Access Compliance Report

Public Rights-of-Way

(Curb Ramps)

Intersection ID: 10018468	Main Street: POSSUM_TROT_LN	Cross Street: N/A	Location: S
ADA ID: 0B33AF76F001	Ramp Type: Perp	Initial Pass/Fail: Fail	Overall Compliance: No
Severity Score: 8.75			
Codes/Mitigation Info/Possible Solution		Field Measurements/Component Compliance

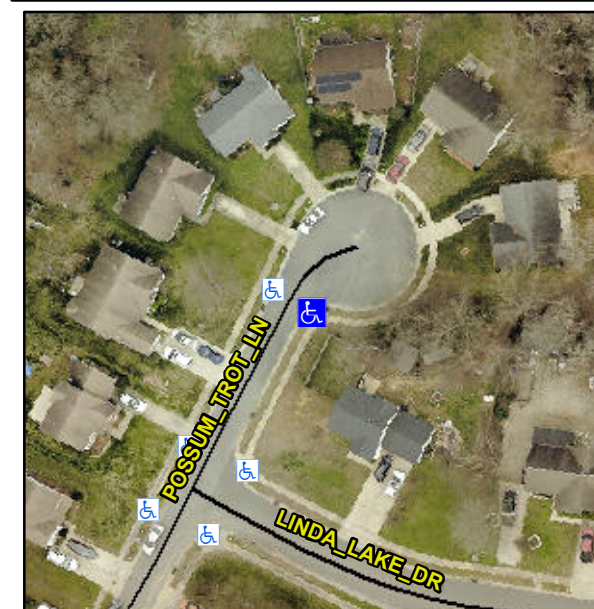
Not Found, R304.5.1

Compliance	Description	Data	Compliance	Description	Data
N/A	Ramp Length (in)	46.0	Yes	Ramp Slope (%)	6.9
No	Ramp Width (in)	45.5	Yes	Ramp XSlope (%)	2.0
N/A	Flare Type LT	N/A	N/A	Flare Type RT	N/A
N/A	Flare Slope LT (%)	N/A	N/A	Flare Slope RT (%)	N/A
N/A	Flare Traversable LT?	N/A	N/A	Flare Traversable RT?	N/A
N/A	Landing Length (in)	N/A	N/A	DWS Provided?	N/A
N/A	Landing Width (in)	N/A	N/A	DWS Contrast?	N/A
N/A	Landing Slope (%)	N/A	N/A	DWS Length (in)	N/A
N/A	Landing X Slope (%)	N/A	N/A	DWS Full Width?	N/A
N/A	Landing Curb? (Y/N)	N/A	N/A	DWS Offset (in)	N/A
N/A	Shared Landing?	N/A			
N/A	Gutter Ponding?	N/A	N/A	Gutter Slope (%)	N/A
N/A	Gutter Lip Ht (in)	N/A	N/A	Gutter X Slope (%)	N/A
N/A	Painted X Walk1?	No	N/A	Painted X Walk2?	N/A
	X Walk 1 Direction	To NW		X Walk 2 Direction	N/A
N/A	X Walk 1 Width (in)	N/A	N/A	X Walk 2 Width (in)	N/A
	X Walk 1 Slope (%)	0.6		X Walk 2 Slope (%)	N/A
	X Walk 1 X Slope (%)	4.1		X Walk 2 X Slope (%)	N/A

Remove & Replace Entire Ramp.
